The Corporation of the District of Saanich

Supplemental Report

To: Mayor and Council
From: Sharon Hvozdzanski, Director of Planning
Date: February 26, 2018
Subject: Development Permit and Rezoning Application
File: DPR00688; REZ00591 • 1586, 1588, 1592 North Dairy Road and
3200 Wordsworth Street

Figure 1: Site Plan

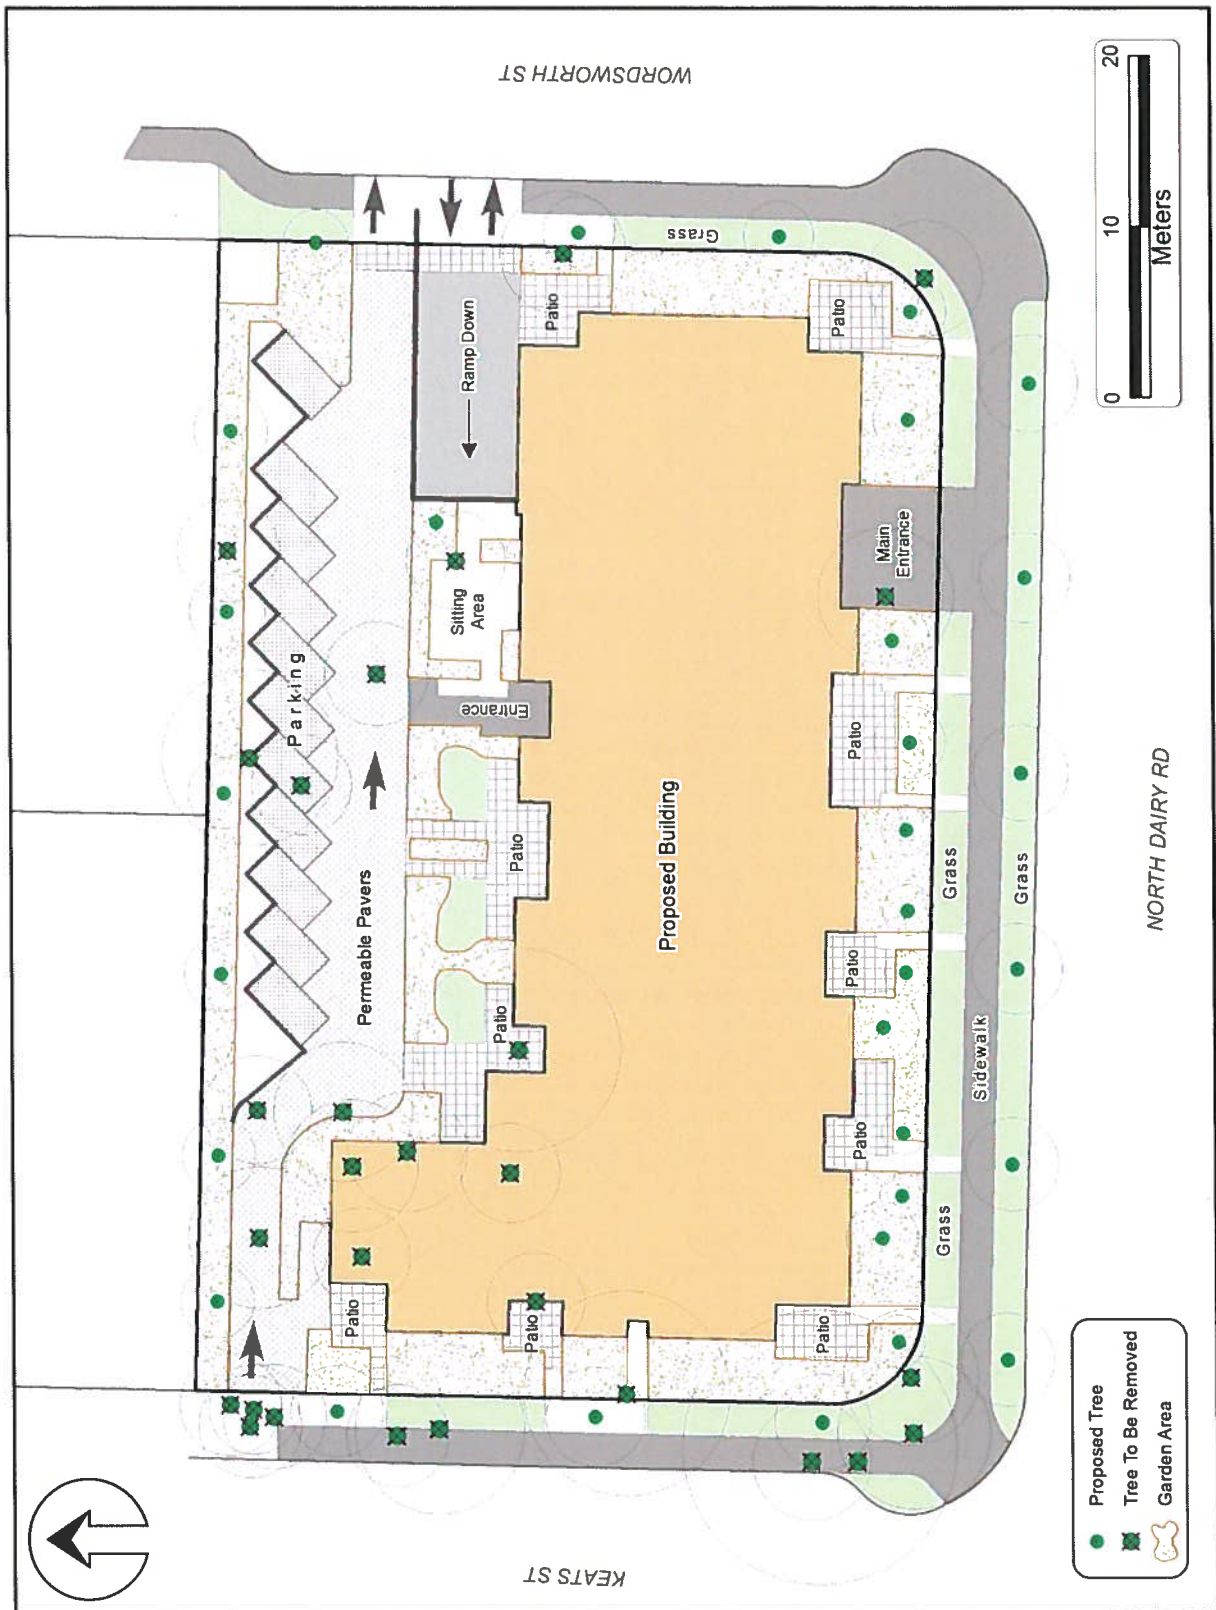
To improve the proposed building's transition to the single family/duplex homes to the north, the rear yard setbacks have been increased and additional stepping of the fourth floor has been added. The building wings are setback an additional 1.4 m, increasing their setback from 6.1 m to 7.5 m from the rear lot line. The fourth floor of the building wings has been setback an additional 4.7 m from the third floor below and is now 12.2 m from the northerly property line. The fourth floor of the wings, facing Keats Street and Wordsworth Street has also been setback 1.9 m from the third floor below to minimize the perceived mass of the building extending up Keats Street and Wordsworth Street. The overall building height has been reduced by 0.65 m. As a result of these changes, the project would no longer shadow the rear yards of either of the homes to the north in fall or spring. Variances are requested for maximum building width and for siting.

- Front Yard Setback (North Dairy Road): 3.0 m proposed whereas the proposed RA-10 Zone requires a front yard setback of 5.0 m.

- Exterior Side Yard Setback: 3.6 m proposed for both exterior side yards whereas the proposed RA-10 Zone requires an exterior side yard setback of 5.0 m.

The proposed building width is 60.29 m, whereas the proposed RA-10 Zone requires a maximum building width of 55 m. The maximum building width regulation is intended to avoid creating large blank walls and to soften impacts from the building’s mass. Articulations along the building elevation and a mix of exterior materials would soften the building mass. Being sited between roadways would also provide a significant distance between the proposed apartment and adjacent buildings fronting North Dairy Road, further reducing impacts. Given the above the requested variance is supportable.
